ATTACHMENT 3

**Mark-ups of Affected
Technical Specifications Pages**

Grand Gulf Nuclear Station

**Mark-ups of Affected
Technical Specifications Bases Pages**

SR 3.3.1.1.15

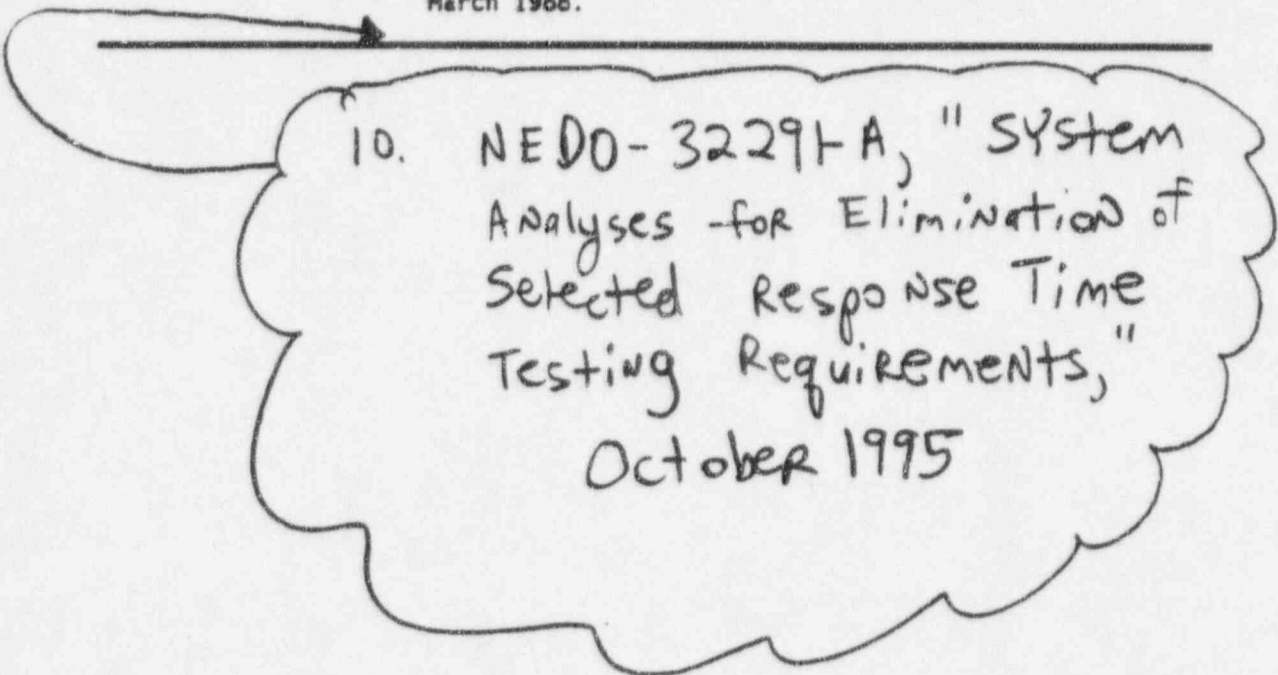
Note 2 allows the channel sensors of Functions 3, 4, and 5 to be excluded from specific RPS RESPONSE TIME testing. This allowance to not perform specific response time testing of the sensors is applicable when the alternate testing requirements and restrictions of Reference 10 are performed. As stated in Reference 10, analysis has demonstrated that other Technical Specification testing requirements (CHANNEL CALIBRATIONS, CHANNEL CHECKS, CHANNEL FUNCTIONAL TESTS, and LOGIC SYSTEM FUNCTIONAL TESTS) and actions taken in response to NRC Bulletin 90-01 Supplement 1 are sufficient to identify failure modes or degradation in instrument response times and assure operation of the analyzed instrument loops within acceptable limits. Reference 10 also identifies that there are no known channel sensor failure modes identified that can be detected by response time testing that cannot also be detected by other Technical Specification required surveillances. Therefore, when the requirements, including sensor types, of Reference 10 are complied with, adequate assurance of the response time of the sensors is provided. This assurance of the response time of the sensors when combined with the response time testing of the remainder of the channel ensures that the individual channel response times are less than or equal to the maximum values assumed in the accident analysis. If the alternate testing requirements of Reference 10 are not complied with, then the entire channel will be response time tested including the sensors.

10. NEDO-32291-A, "System Analyses for Elimination of Selected Response Time Testing Requirements,"
October 1995

SR 3.3.6.1.8

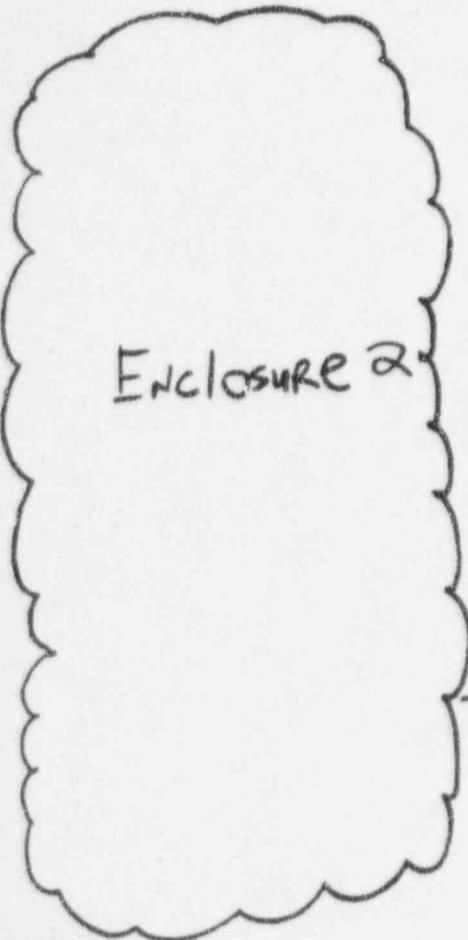
This SR ensures that the individual channel response times are less than or equal to the maximum values assumed in the accident analysis. Testing is performed only on channels where the assumed response time does not correspond to the diesel generator (DG) start time. For channels assumed to respond within the DG start time, sufficient margin exists in the 10 second start time when compared to the typical channel response time (milliseconds) so as to assure adequate response without a specific measurement test. Testing of the closure times of the MSIVs is not included in this Surveillance since the closure time of the MSIVs is tested by SR 3.6.1.3.6. ISOLATION SYSTEM RESPONSE TIME acceptance criteria for this instrumentation is included in the applicable plant procedures.

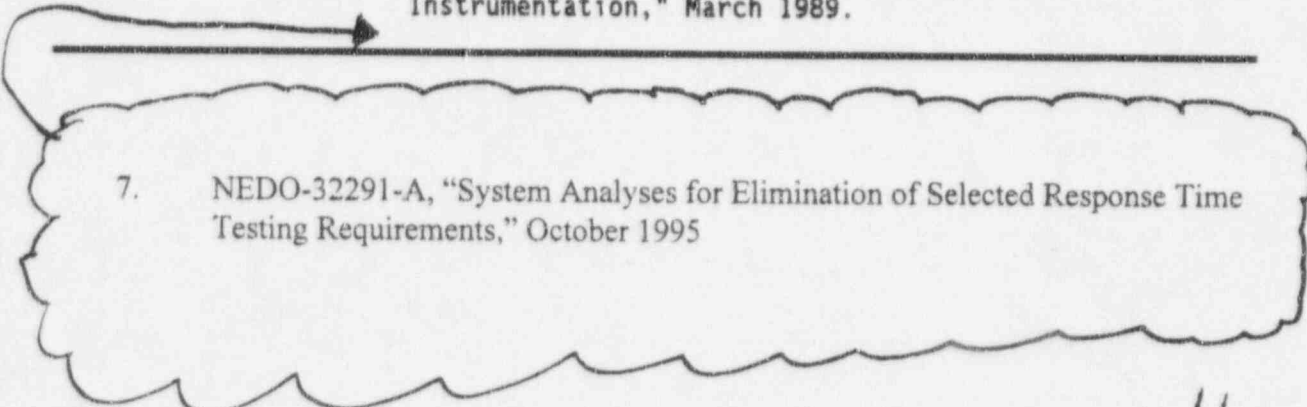
As Noted, the channel sensor may be excluded from response time testing. This allowance to not perform specific response time testing of the sensors is applicable when the alternate testing requirements and restrictions of Reference 7 are performed. As stated in Reference 7, analysis has demonstrated that other Technical Specification testing requirements (CHANNEL CALIBRATIONS, CHANNEL CHECKS, CHANNEL FUNCTIONAL TESTS, and LOGIC SYSTEM FUNCTIONAL TESTS) and actions taken in response to NRC Bulletin 90-01 Supplement 1 are sufficient to identify failure modes or degradation in instrument response times and assure operation of the analyzed instrument loops within acceptable limits. Reference 7 also identifies that there are no known channel sensor failure modes identified that can be detected by response time testing that cannot also be detected by other Technical Specification required surveillances. Therefore, when the requirements, including sensor types, of Reference 7 are complied with, adequate assurance of the response time of the sensors is provided. This assurance of the response time of the sensors when combined with the response time testing of the remainder of the channel ensures that the individual channel response times are less than or equal to the maximum values assumed in the accident analysis. If the alternate testing requirements of Reference 7 are not complied with then the entire channel will be response time tested including the sensors.

- 
7. NEDO-32291-A, "System Analyses for Elimination of Selected Response Time Testing Requirements," October 1995

SR 3.5.1.8

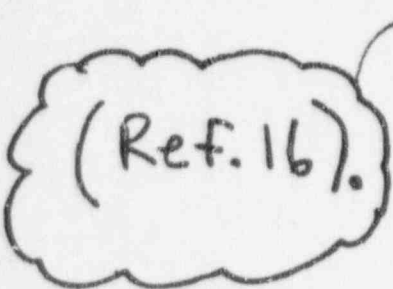
This SR ensures that the HPCS System response time is less than or equal to the maximum value assumed in the accident analysis. Specific testing of the ECCS actuation instrumentation inputs into the HPCS System ECCS SYSTEM RESPONSE TIME is not required by this SR. Specific response time testing of this instrumentation is not required since these actuation channels are only assumed to respond within the diesel generator start time; therefore, sufficient margin exists in the diesel generator 10 second start time when compared to the typical channel response time (milliseconds) so as to assure adequate response without a specific measurement test. The diesel generator starting and any sequence loading delays along with the Reactor Vessel Water Level - Low Low, Level 2 confirmation delay permissive must be added to the HPCS System equipment response times to obtain the HPCS System ECCS SYSTEM RESPONSE TIME. The acceptance criterion for the HPCS System ECCS SYSTEM RESPONSE TIME is ≤ 27 seconds.

(Ref. 16).

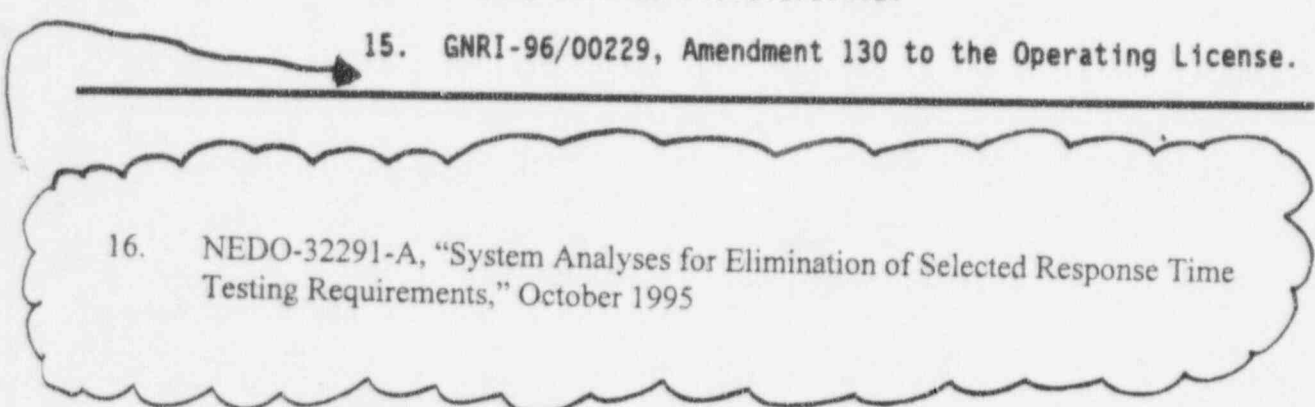
- 
16. NEDO-32291-A, "System Analyses for Elimination of Selected Response Time Testing Requirements," October 1995
